RAMP REPORT REGION 2 ADA 2026

Route 7 – Vine Street
Belfast

Wentworth Family Quick Stop– CR20046

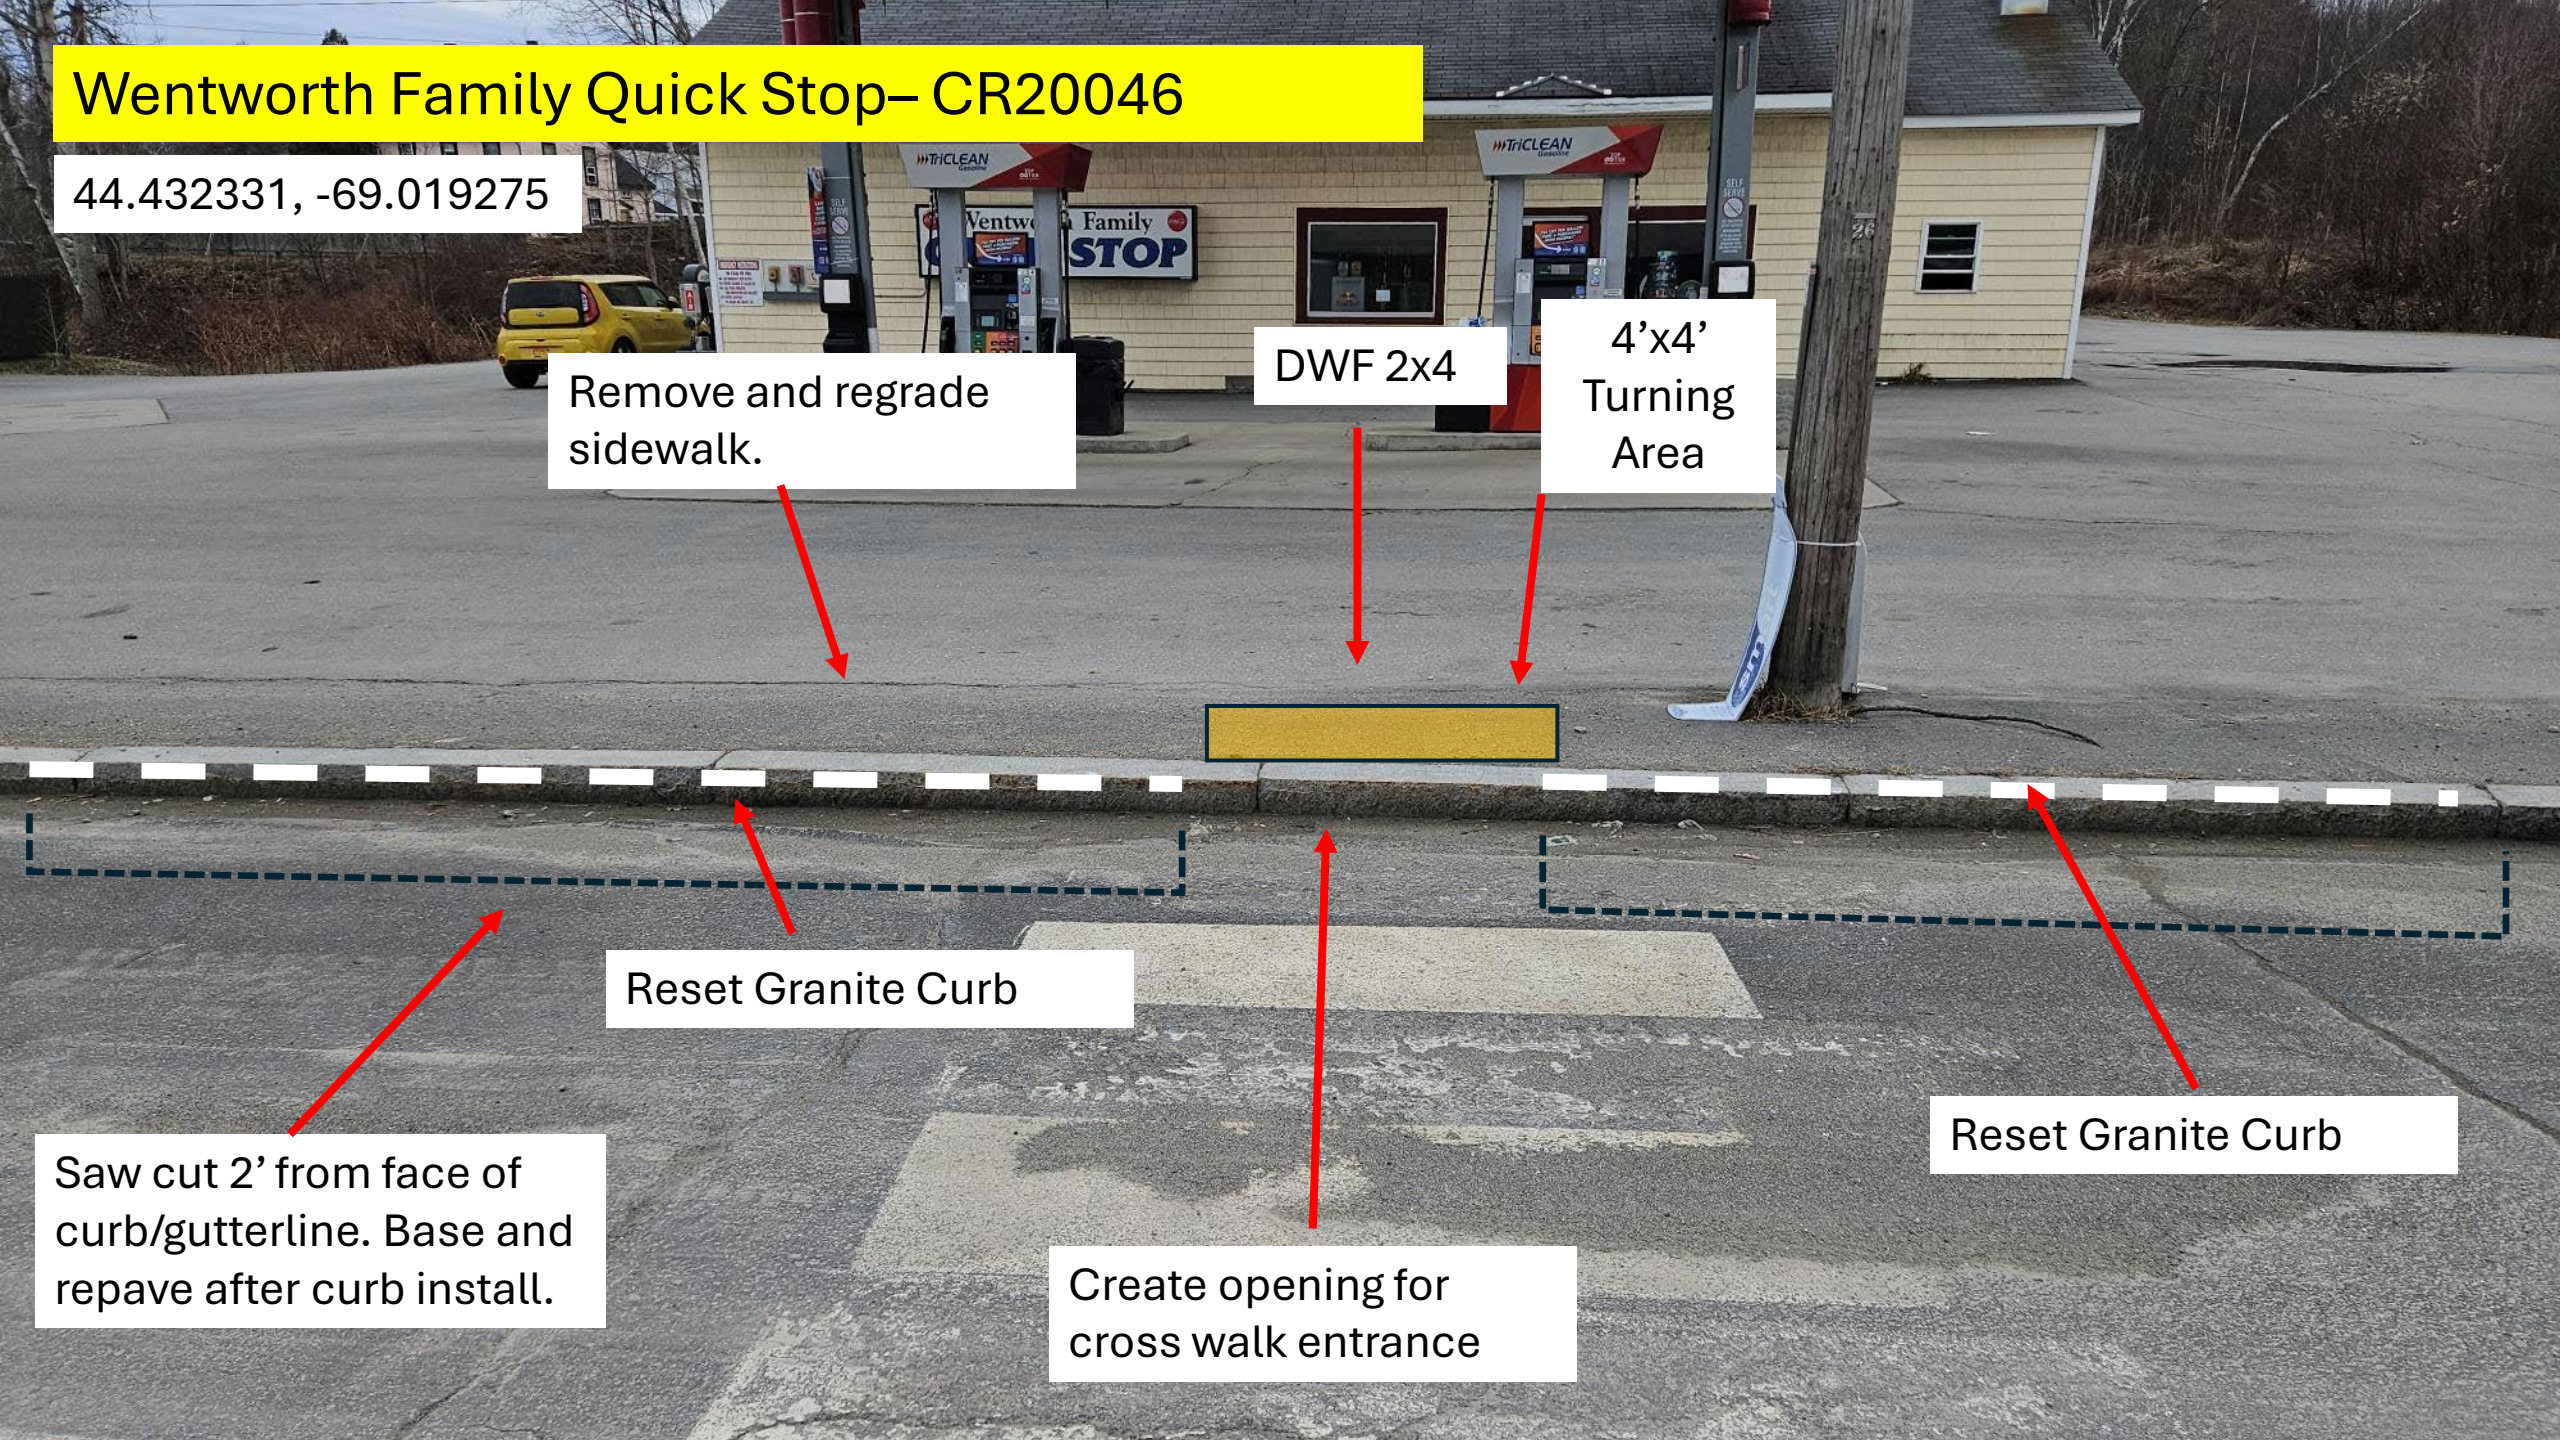
Remove and regrade sidewalk.

DWF 2x4

4'x4' Turning Area

Reset Granite Curb

Saw cut 2' from face of curb/gutterline. Base and repave after curb install.

Create opening for cross walk entrance

Reset Granite Curb

Park Place Suites– CR13576

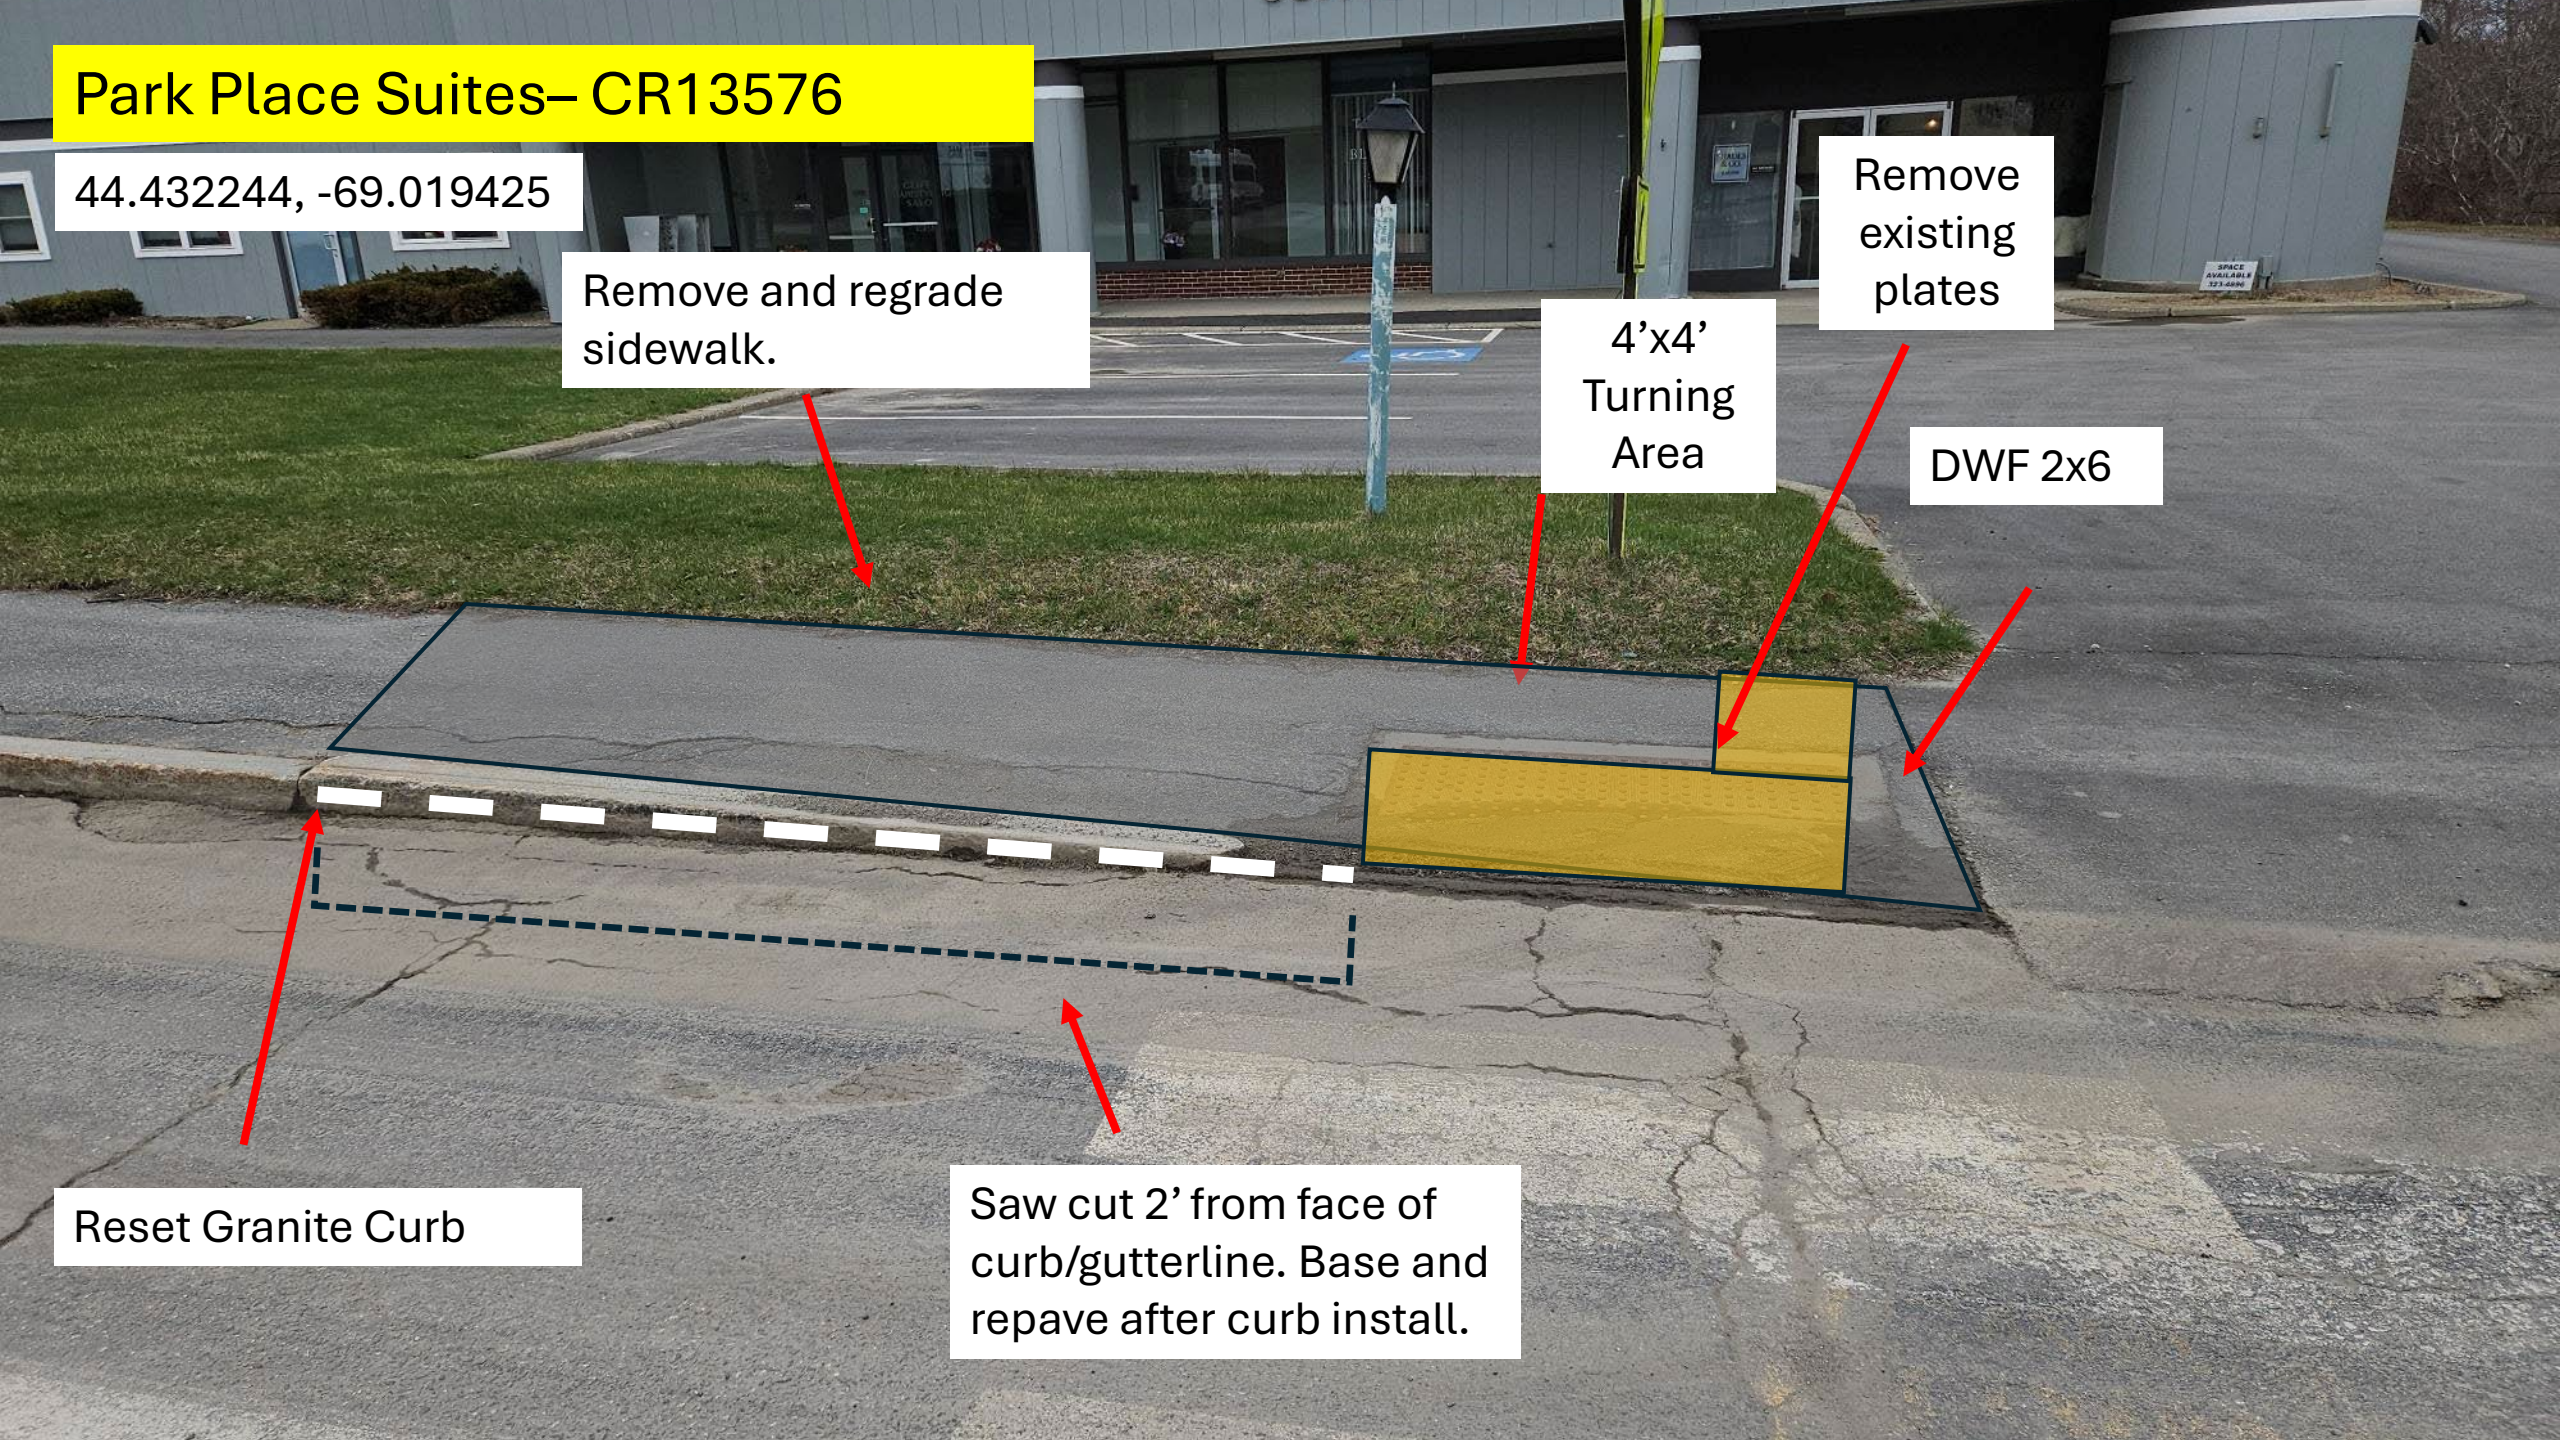
Remove and regrade sidewalk.

4'x4'
Turning
Area

Remove
existing
plates

DWF 2x6

Reset Granite Curb

Saw cut 2' from face of
curb/gutterline. Base and
repave after curb install.

Merriam Dr. East side – CR20048

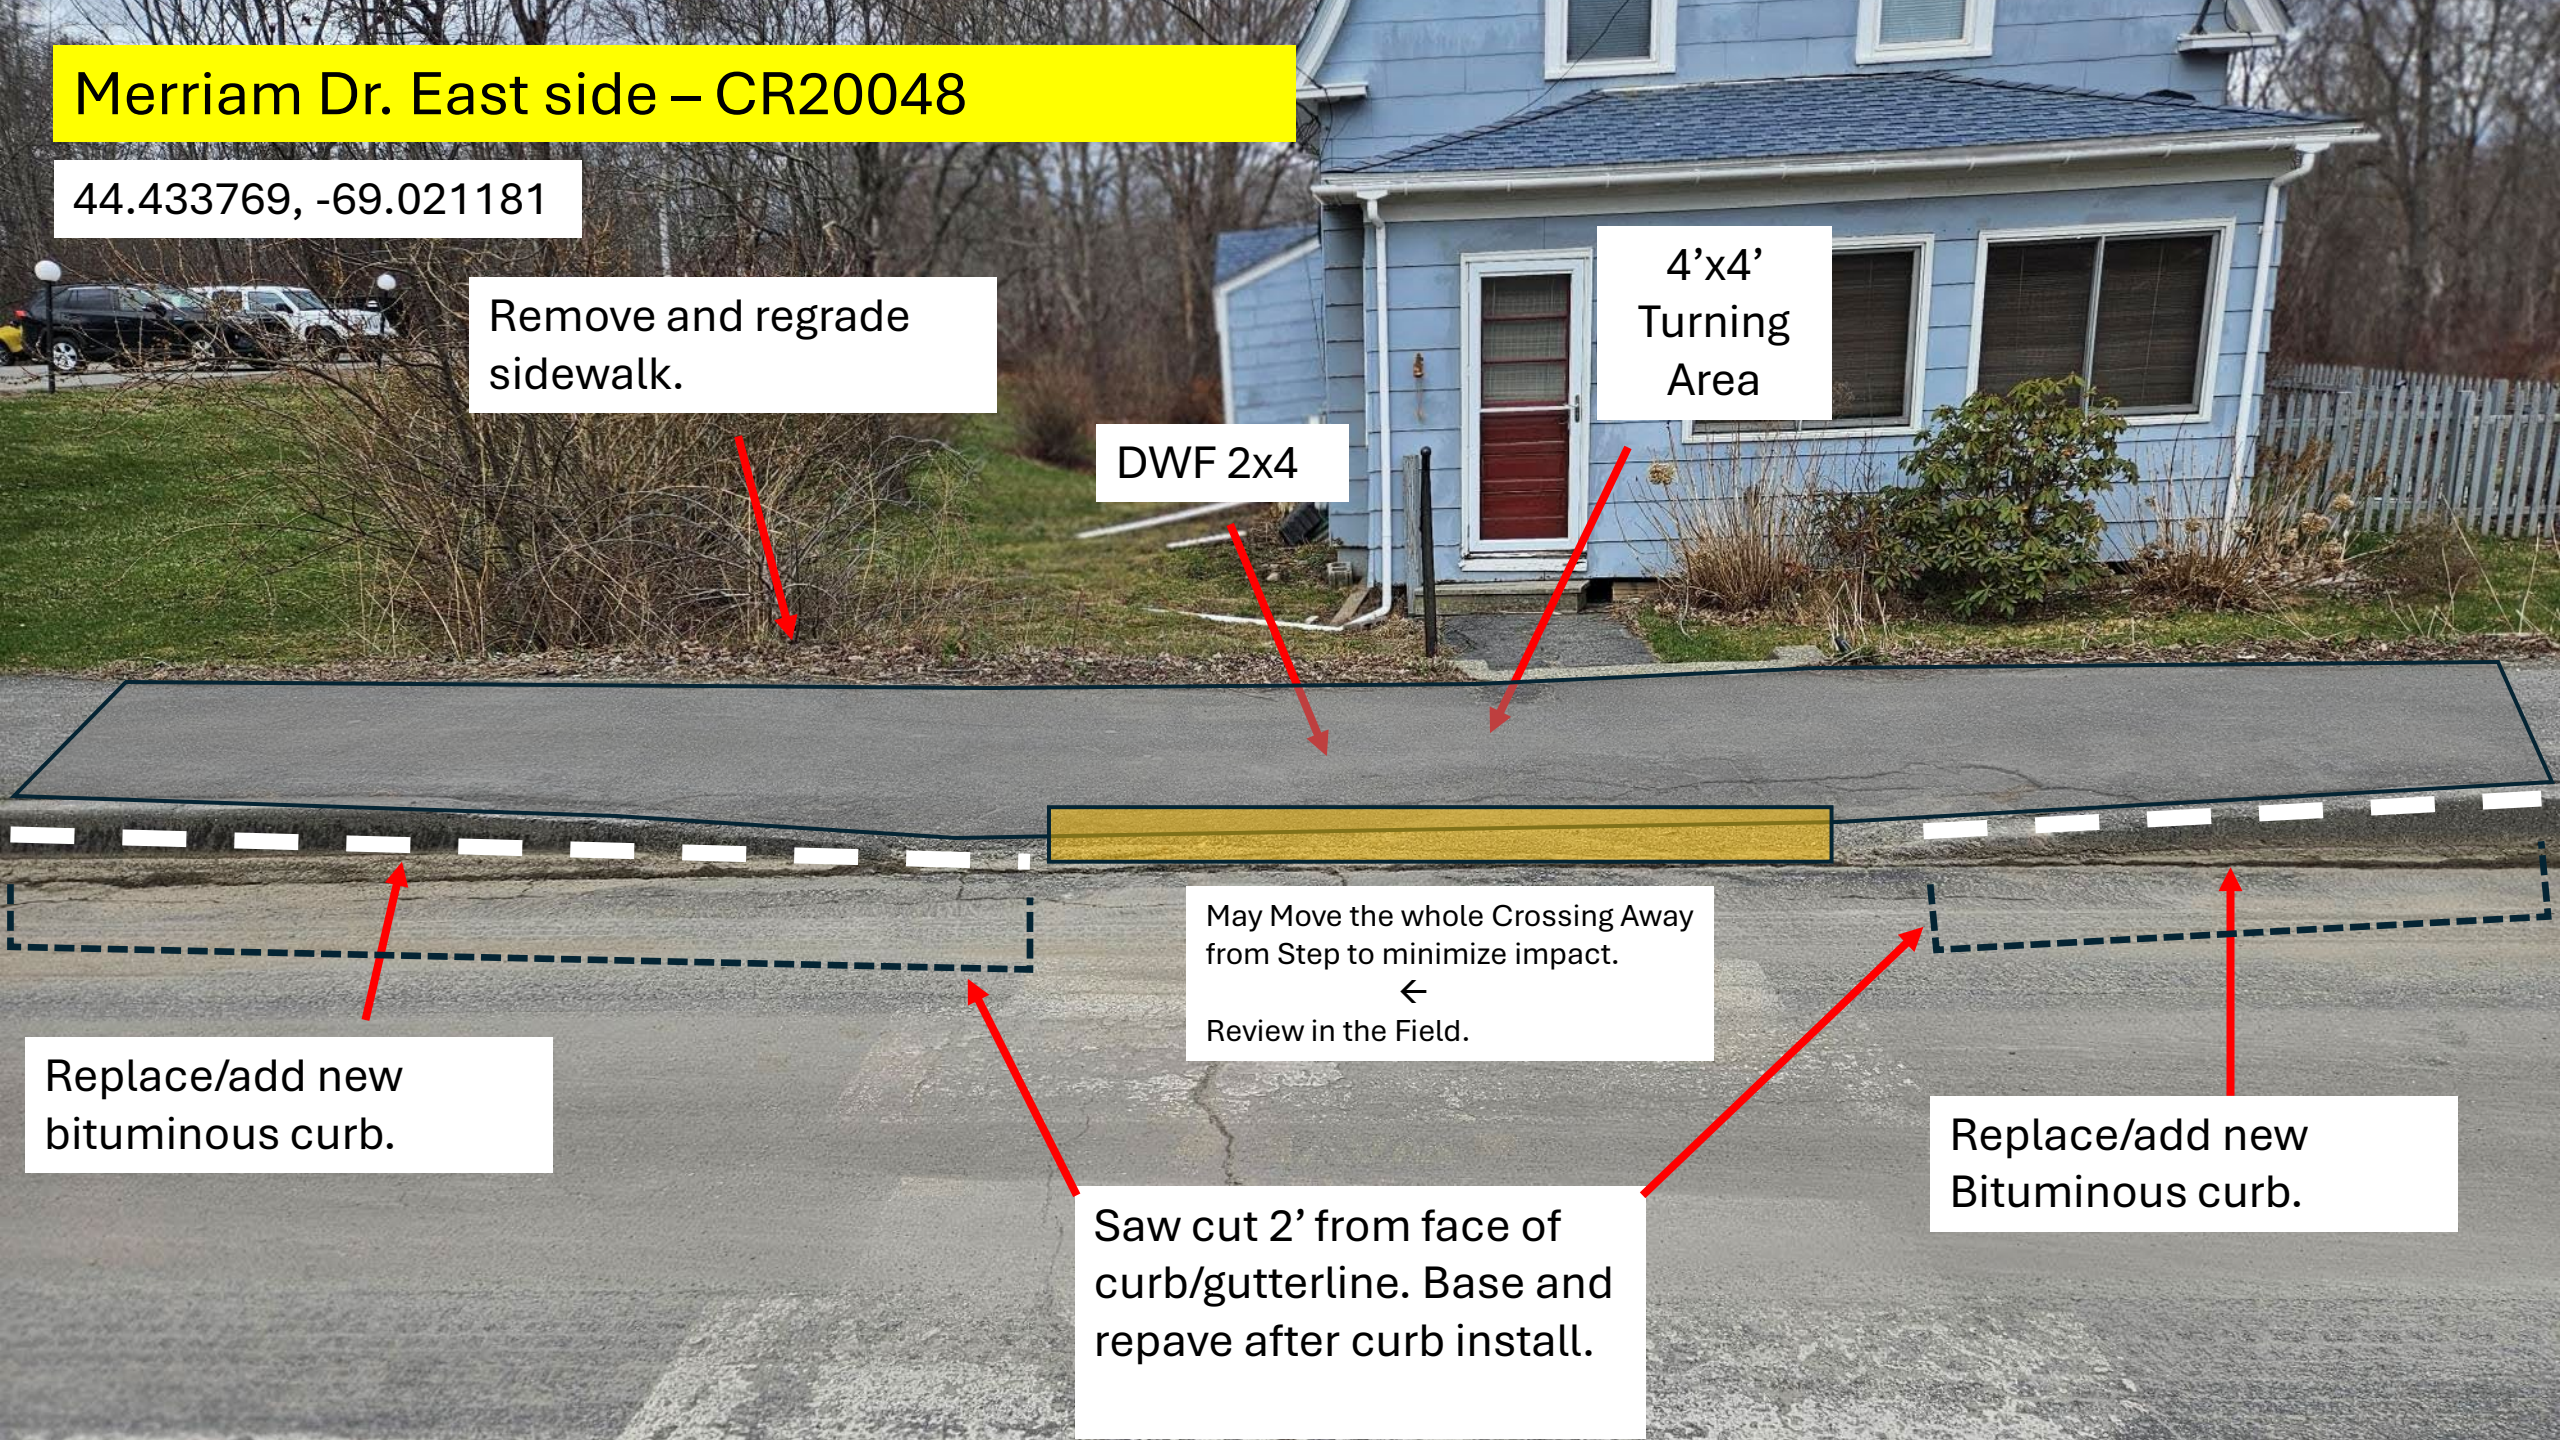
Remove and regrade sidewalk.

DWF 2x4

4'x4' Turning Area

May Move the whole Crossing Away from Step to minimize impact.
←
Review in the Field.

Replace/add new bituminous curb.

Saw cut 2' from face of curb/gutterline. Base and repave after curb install.

Replace/add new Bituminous curb.
